Customer : CU-DAR001 Dart Helicopters Services	Drawing Name : HELI UTILITY BASKET LH/RH 350/355
Job Number : 48299	
Estimate Number : 10208	
P.O. Number :	Part Number : D350607043
This Issue : 29/05/2009 S.O. No. :	Drawing Number : D350-607 REV F P7-9
Prsht Rev. : NC	Project Number : N/A
First Issue : 29/05/2009 Type : LARGE FAB ASSY	Drawing Revision : F
Previous Run : 48298	Material :
Written By :	Due Date : 08/06/2009 Qty: 1 Um: Each
Checked & Approved By : <u>JUD 09-05-29</u>	
Comment : Est Rev:E as Per DSI9318 06-01-24 JLM	
Est Rev:F ECN1068 07-12-21 DD verified by:

DESIGN <i>CP</i>	DRAWN BY <i>CP</i>	DART AEROSPACE LTD HAWKESBURY, ONTARIO, CANADA	
CHECKED <i>[Signature]</i>	APPROVED <i>[Signature]</i>	DRAWING NO. DSI 9318	REV. A SHEET 1 OF 1
DATE 06.01.06		TITLE WASHER ADDITION	SCALE NTS
A	06.01.06	NEW ISSUE

DART SERVICE INSTRUCTION

TO AMEND INSTALLATION INSTRUCTIONS D350-607 REV. F

Figure 5- Basket Replacement Parts
(D350-607-043 Heli-Utility-Basket™)

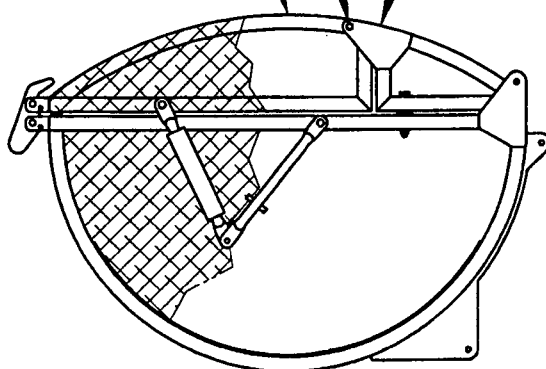
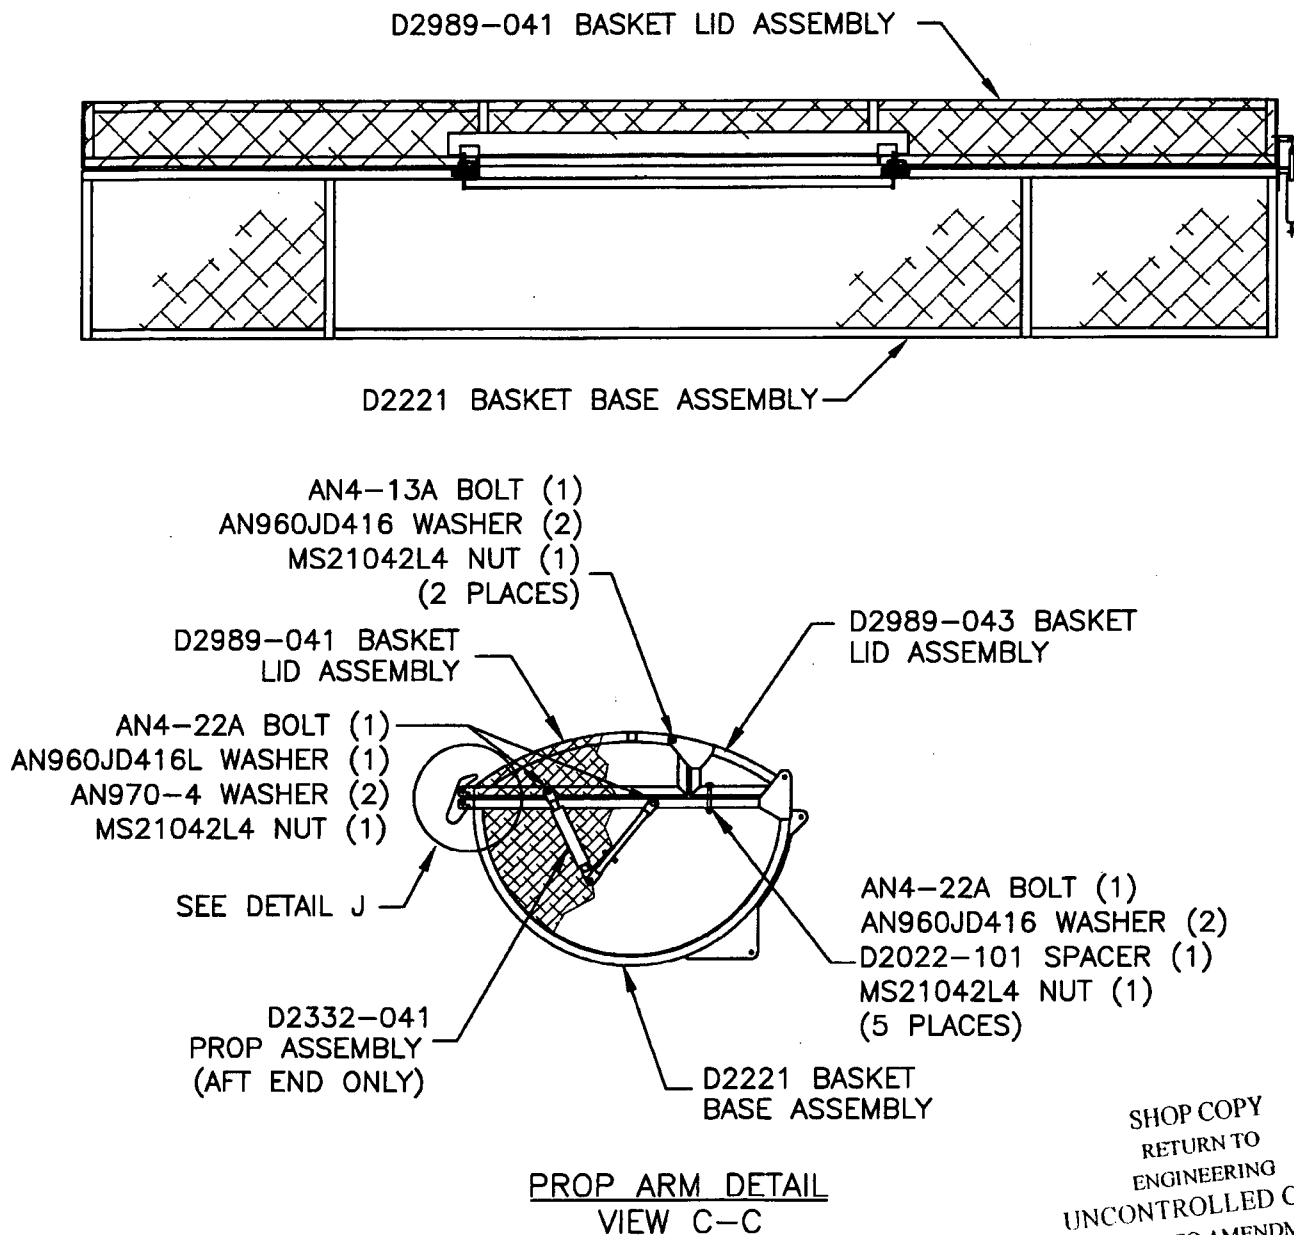
To reduce the possibility of damaging the finish, a **NAS1515H4** washer (2 places) has been added between the hinge plate and basket frame on the **D350-607-043/-047 Heli-Utility-Basket**.

The corrected bolt stackup from Figure 5 of installation instructions D350-607 Rev. F is given below:

AN4-13A BOLT (1)
AN960JD416 WASHER (1)
HINGE PLATE (REF)
NAS1515H4 WASHER (1)
BASKET FRAME (REF)
AN960JD416 WASHER (1)
MS21042L4 NUT (1)
(2 PLACES)
